FINAL DECISION DOCUMENT FOR THE INTERIM RESPONSE ACTION AT THE M-1 SETTLING
BASINS ROCKY MOUNTAIN ARSENAL, VERSION 4.0

**FINAL DECISION DOCUMENT
FOR THE INTERIM RESPONSE ACTION
AT THE
M-1 SETTLING BASINS
ROCKY MOUNTAIN ARSENAL
MARCH 1990
CONTRACT NO. DAAA15-88-D-0022/0002
VERSION 4.0**

RESPONSE TO COMMENTS FROM THE EPA
ON THE PROPOSED DECISION DOCUMENT
FOR THE M-1 SETTLING BASINS
NOVEMBER 1989

RESPONSE TO COMMENTS FROM SHELL OIL COMPANY
ON PROPOSED DECISION DOCUMENT
FOR THE INTERIM RESPONSE ACTION
AT THE M-1 SETTLING BASINS
VERSION 2.0
NOVEMBER 1989

Figure 2-2

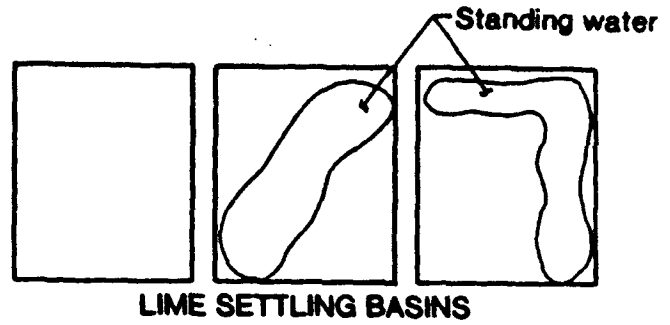
Comment 1: The groundwater elevation has been estimated on Figure 2-2, yet the saturated thickness of alluvium with seasonal variations, which affects several alternative actions, is not discussed.

Response: The text has been revised to discuss this point (Section 2.0). Figure 2-2 has been revised. The groundwater elevations have been removed since they are not relevant to the location map.
